# XLAUI/CAUI TP4 VMA specification issue (Clause 83B)

8th September 2011

# Minimum VMA spec in Clause 83B: the issue

Figure 83A-8—Transmitter eye mask

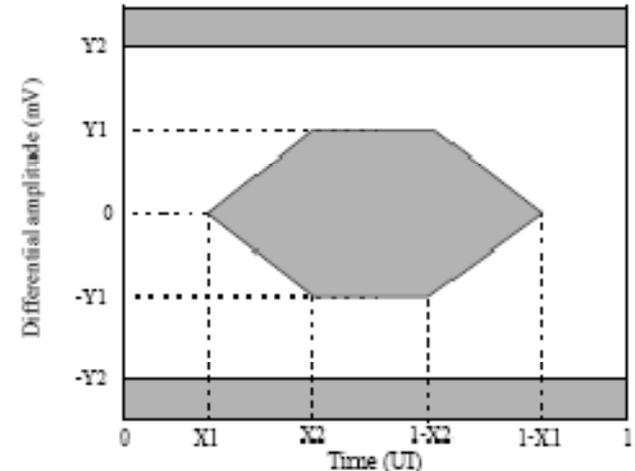
Eye-mask for module TP4 electrical output (note that the eye mask is a diamond shape , since  $X2=0.5$ )

- There is a minimum 272 mV VMA implied by the electrical eye mask definition, which is for a 0 dB de-emphasis signal and any rise time.
- During the development of 83B, a Finite Impulse Response (FIR) implementation with constant main tap setting was assumed for adding de-emphasis; the intent was that the minimum VMA specified in 83B-6 should be consistent with an FIR implementation of de-emphasis for the 0dB de-emphasis transmitter eye mask test value, and over the operating range of 3.5 to 6 dB de-emphasis range.

# Minimum VMA spec in Clause 83B: the issue

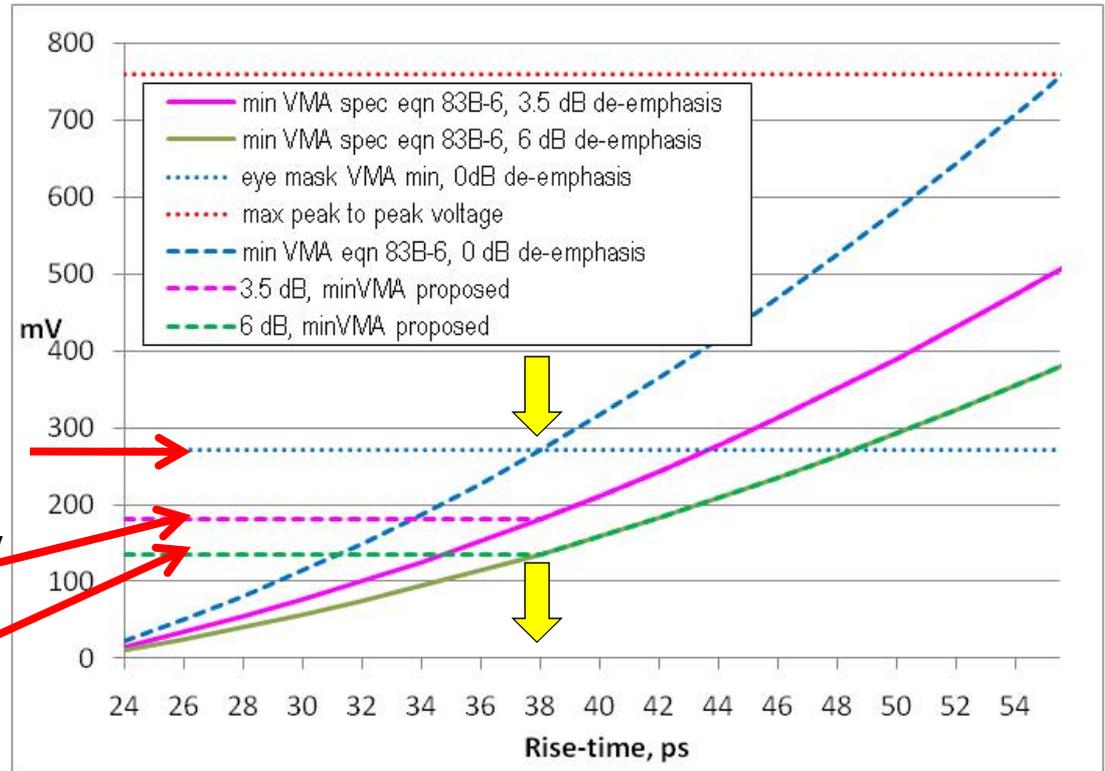
- For a FIR with constant main tap, a 0 dB de-emphasis eye with 272 mV VMA would be equivalent to
  - a 3.5 dB de-emphasis eye with 181.2 mV VMA, and
  - a 6 dB de-emphasis eye with 135.9 mV VMA.

- However, a FIR implementation cannot be assumed – it is not a normative requirement of clause 83B (there are many other methods of implementing ‘de-emphasis’), so there’s a missing normative link between the minimum VMA at 0 dB de-emphasis and the minimum VMA for the 3.5 to 6 dB de-emphasis range for very fast module output rise-times.
- The intent here is modify 83B-6 to make the minimum VMA implied by an assumed FIR characteristic explicit.

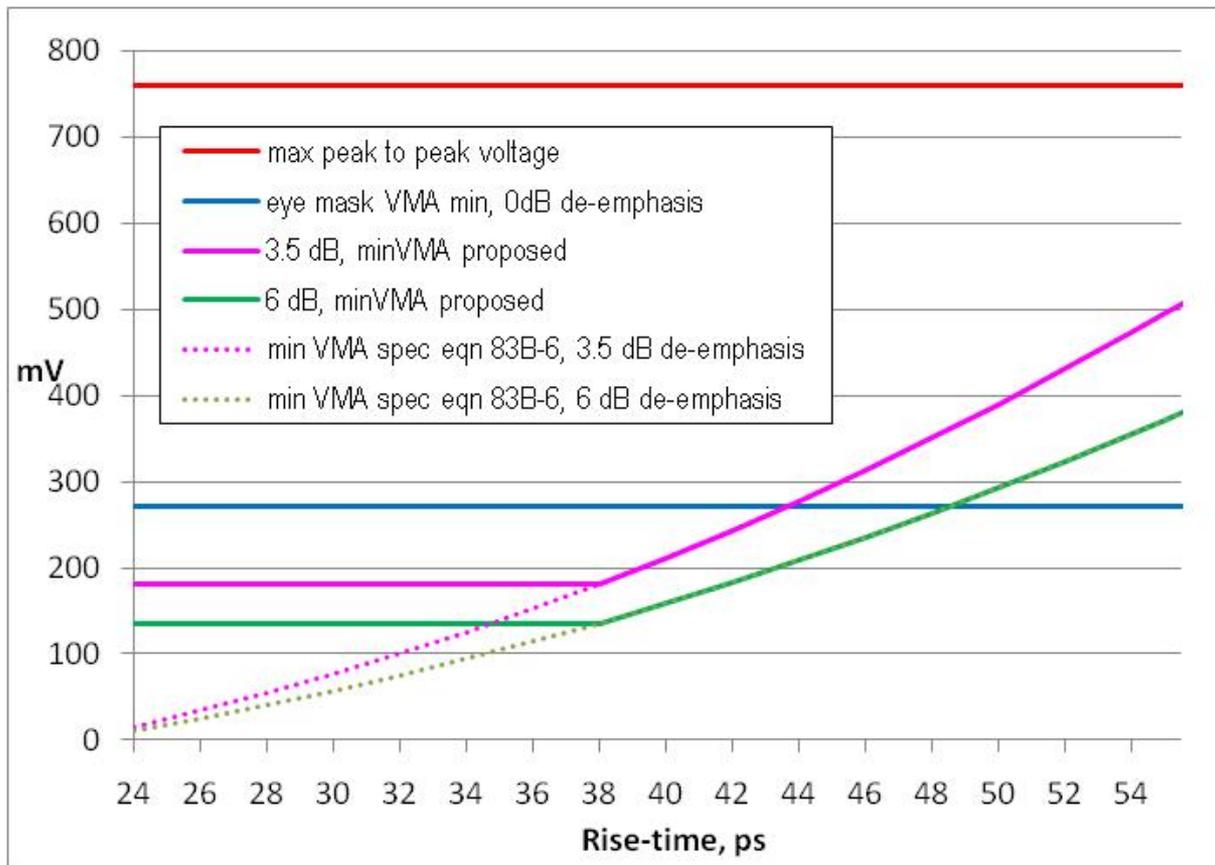
- Change equation 83B-6 from

$\text{Minimum VMA (mV)} = (-110 - 2.13x + 0.32x^2) \times 10^{-y/20}$
where	
$x$	is the rise or fall time (whichever is larger) in ps
$y$	is de-emphasis value in dB

- to

$\text{Minimum VMA (mV)} = (-110 - 2.13x + 0.32x^2) \times 10^{-y/20}$
where	
$x$	is the rise or fall time, <b>or 38</b> , (whichever is larger) in ps
$y$	is de-emphasis value in dB

*38 is based on the module XLAUI Tx eye mask spec and an assumed FIR implementation, as was the original intent of the experts developing 83B.*

The effect of setting a minimum allowed value of 38 ps transition time in equation 83B-6 is to set a minimum VMA of 181.2mV for 3.5dB de-emphasis, and 135.9 mV for 6dB de-emphasis.
